The General Manager Willoughby City Council

Re: The Haven Amphitheatre Committee's proposal for stage and associated works for the Haven Amphitheatre

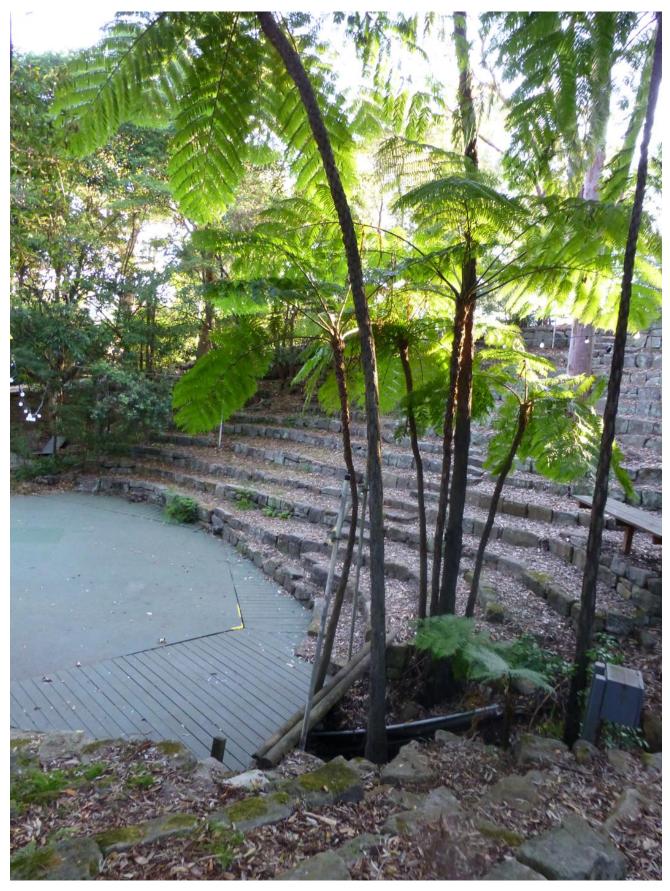
- 9. The impact of the enlarged stage and additional excavation on a very significant *Angophora costata*, Sydney Red Gum. The proposed stage protrudes into the root zone of this historic tree (see attached photograph of the tree beside the creek with its roots very close to the existing stage).

Angophora costata (Sydney Red Gum) growing beside the existing timber structure and beside the creek, 2013.

If a concrete structure were to be built as proposed by HAC it would cause the demise of this now large and healthy Angophora.
